22 November 2021

## **RE: Site Plan Application at 93 Pleasant Street, Tax Map 107; Lot 74**

SUBJECT: Treadwell Mansion Redevelopment  
#93 Pleasant Street  
Response to Peer Review Comments

**SIGHT  
DISTANCE  
PLAN**

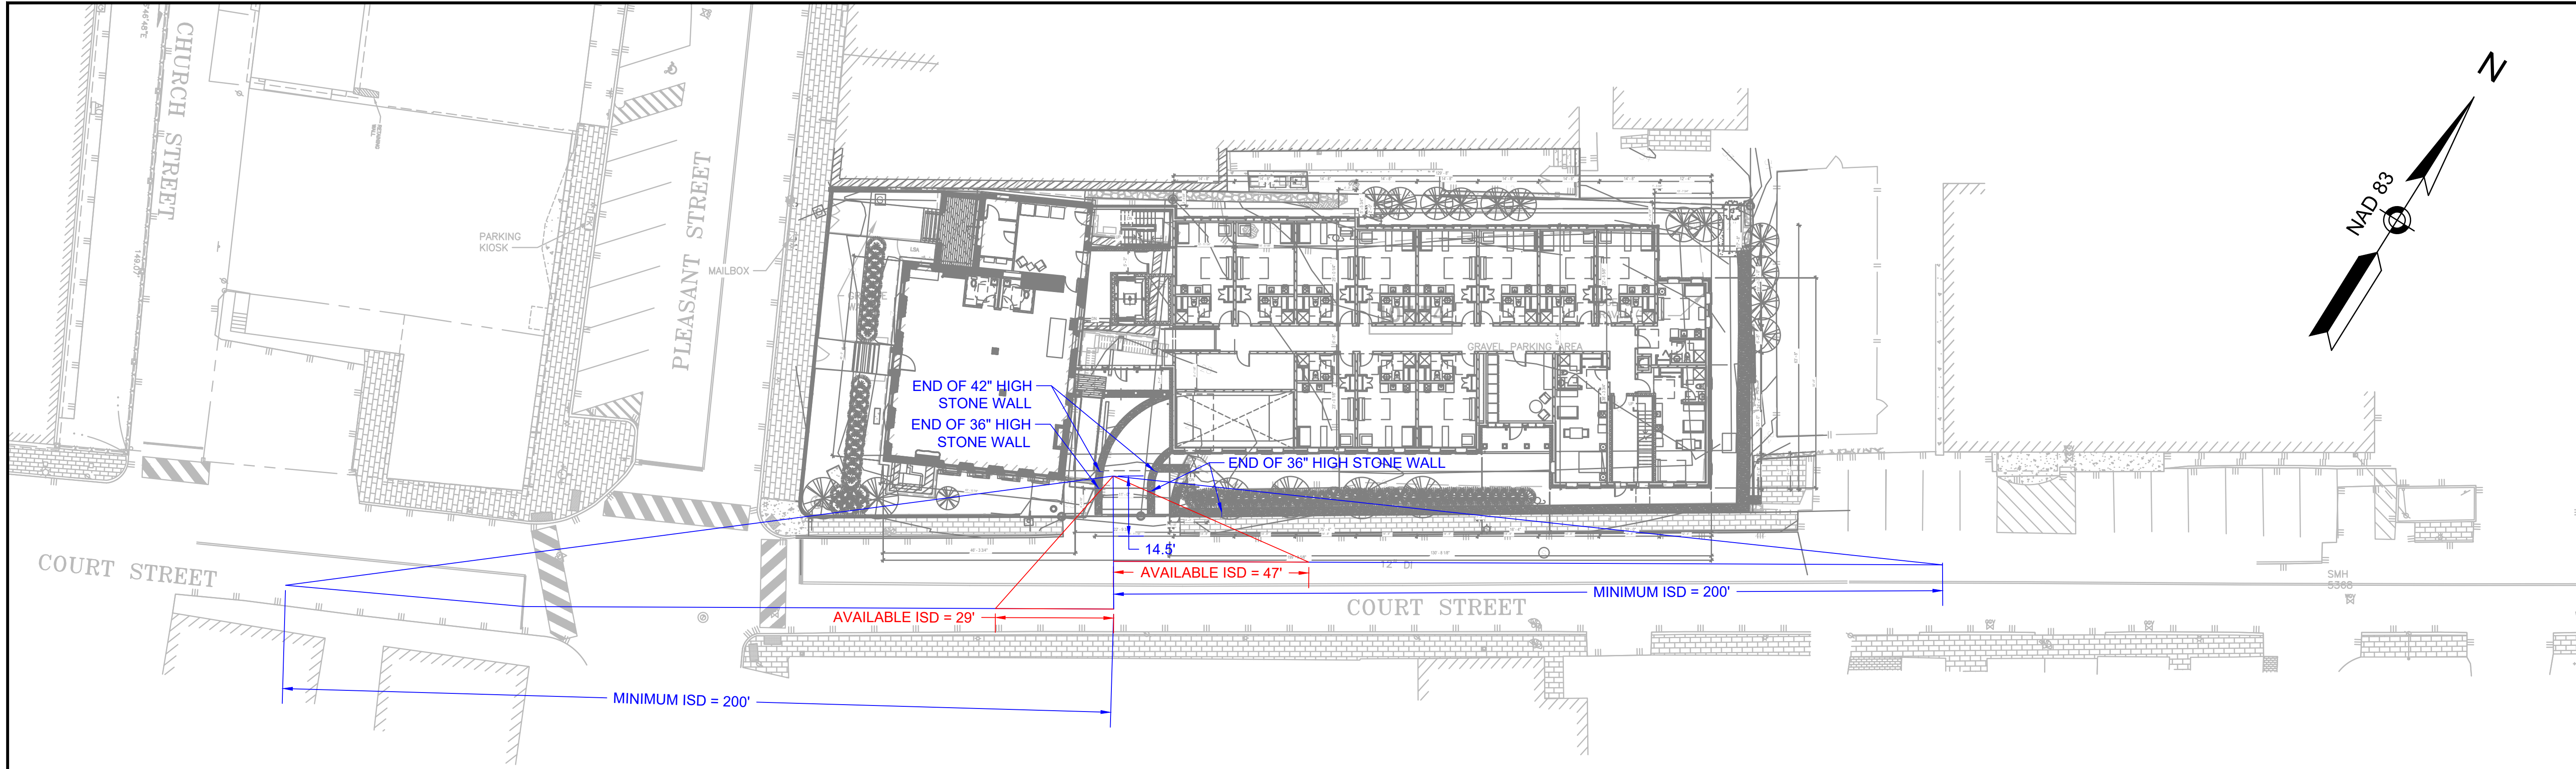
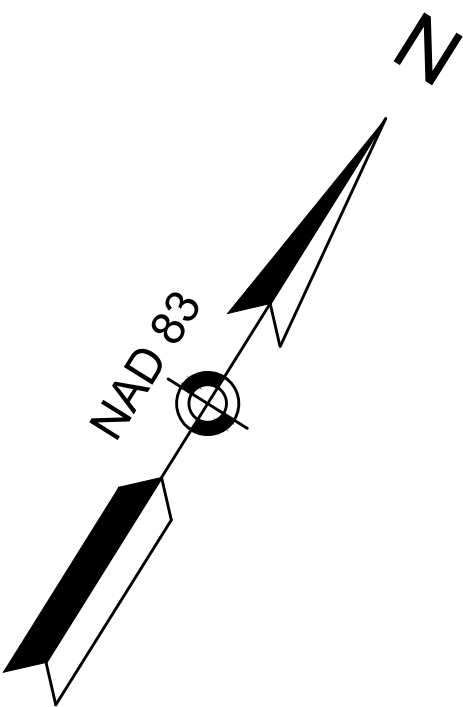
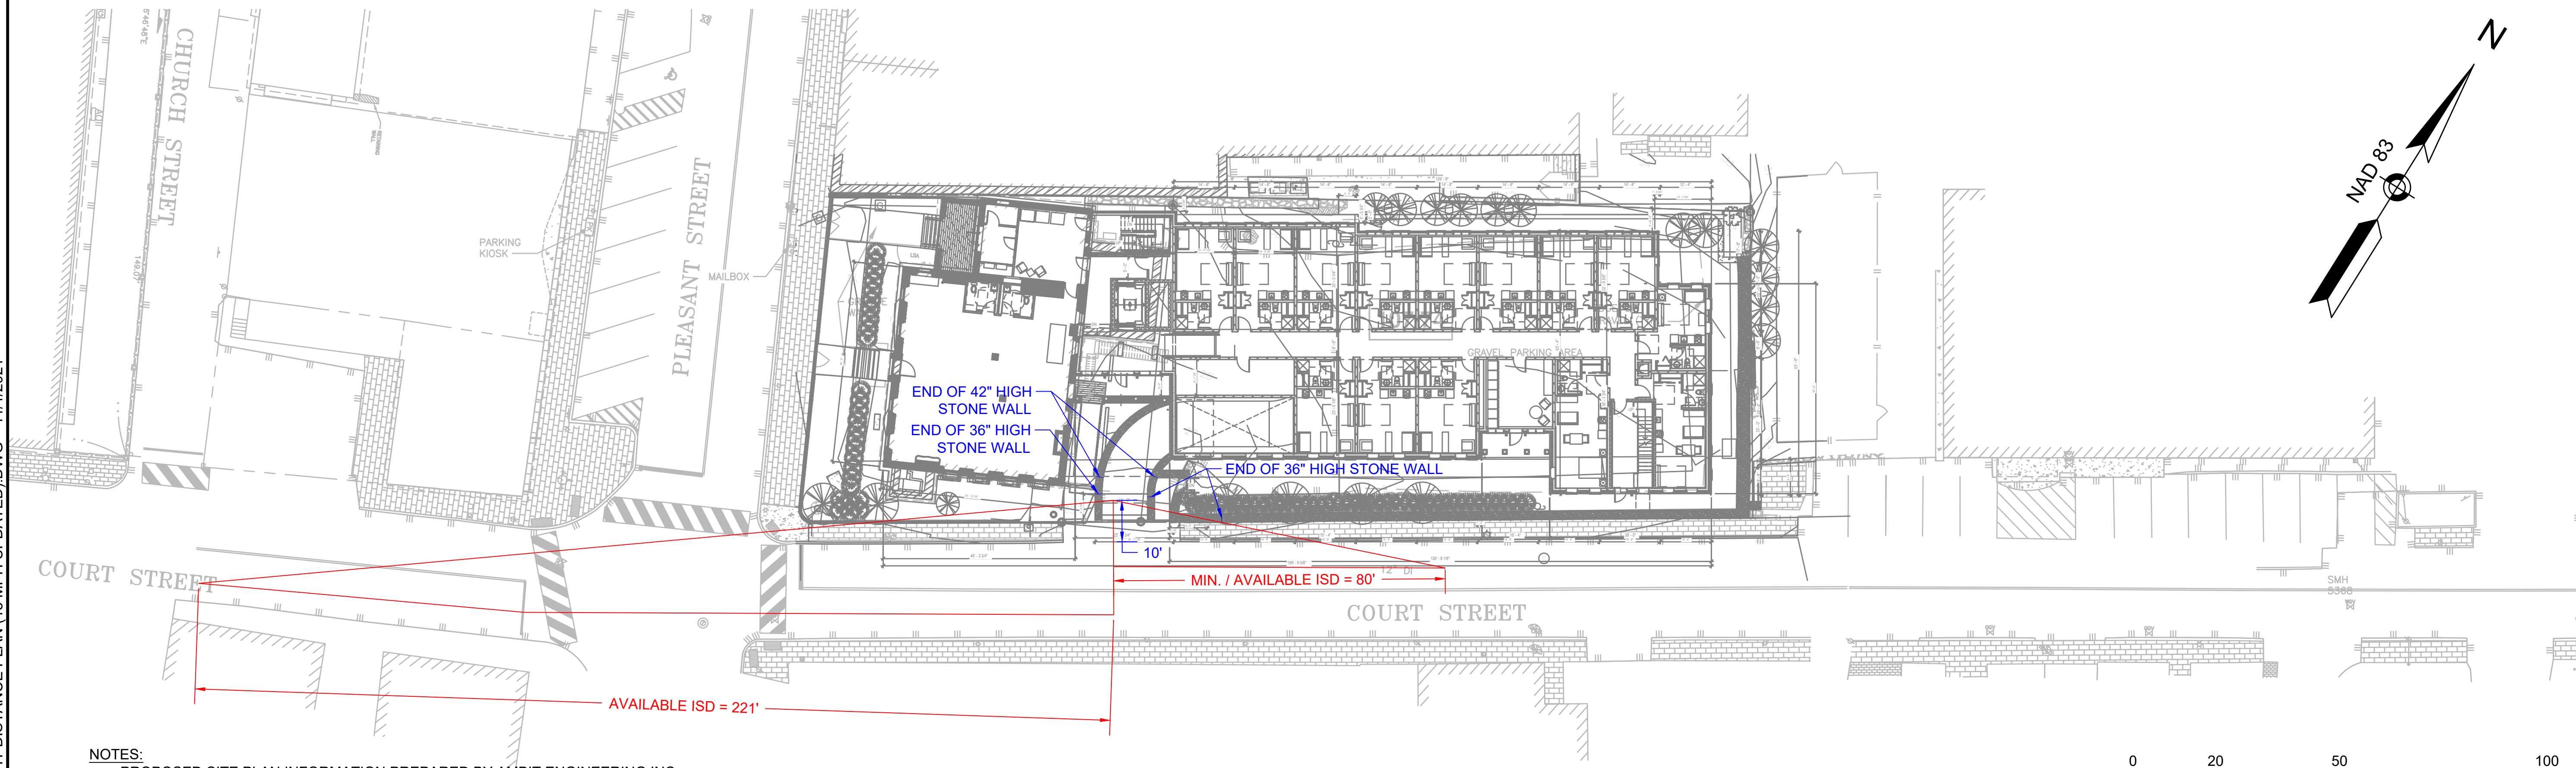
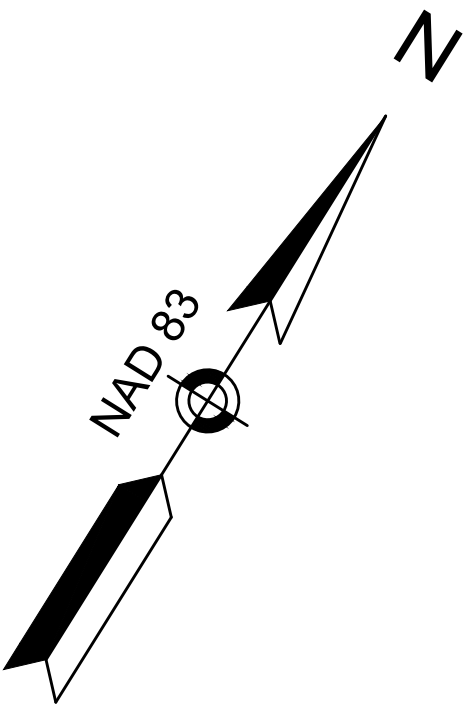
**Comment 2:** *Per the City of Portsmouth Ordinance Chapter 7 – Vehicles, Traffic and Parking Ordinance, the statutory speed limit along Court Street is 30 miles per hour (mph), not 25 mph as stated within the TIAS. TEC acknowledges that vehicles approaching the site driveway along both directions of Court Street will be coming from a stop condition at the intersections of either Washington Street or Pleasant Street and likely not reaching a speed of 30 mph by the site driveway. The Stopping Sight Distance (SSD) required for vehicles traveling 30 mph is 200 feet. Table 2 of the TIA indicated that over 200 feet of SSD is available along Court Street for vehicles approaching the new driveway location. The stopping sight distances reported in Table 2 of the TIA*

**Response 2:** The site plans have been modified to relocate the driveway further west to improve sight lines exiting the site driveway and increase the separation between the proposed site driveway and the parking along the adjacent Temple Israel property. An updated sight line analysis has been performed for the relocated site driveway. As noted by TEC, the enforceable speed along Court Street is 30 miles per hour (MPH) based on the City's Ordinances. Based on a travel speed of 30 MPH, the minimum required Stopping Sight Distance (SSD) and Intersection Sight Distance (ISD) would be 200 feet. However, the site driveway will be located approximately 80 feet to the east of the STOP line on Court Street at the intersection with Pleasant Street. Based on AASHTO guidelines for SSD, vehicles passing by the relocated site driveway in the westbound direction would need to be traveling at a speed of 15 MPH or less in order to safely stop for the STOP line at the Court Street / Pleasant Street intersection. Due to the four-way STOP control, all vehicles approaching the site driveway in the eastbound direction will be coming from a stopped condition. Therefore, the sight line analysis has also been performed for a travel speed of 15 MPH passing by the site driveway.

The updated sight distance measurements are summarized in Table 1 and the *Sight Distance Plan* is provided as an Attachment to this letter. The updated analysis shows that the available Stopping Sight Distance (SSD) will exceed 400 feet in either direction, exceeding AASHTO recommendations for safe sight lines. The sight line analysis Intersection Sight Distance (ISD) has been prepared at a driver's eye distance of 14.5 feet from the edge of the travelway as required by AASHTO, as well as for a driver's eye at a distance of 10 feet from the edge of travelway. The 14.5-foot separation from the edge of the travelway represents a vehicle exiting the garage stopped in advance of the sidewalk. Although the ISD will be limited to 29 to 47 feet at this point, from this location the driver will have adequate ISD to check for pedestrians approaching on the sidewalk. The driver would then be able to pull their vehicle forward to edge of the roadway, placing the driver's eye approximately 10 feet from the edge of the travelway. At this point, the ISD would be extended to 80 to 221 feet, providing the driver exiting the site driveway with adequate ISD of oncoming vehicle traffic to meet AASHTO recommendations for minimum ISD based on a travel speed of 15 MPH.
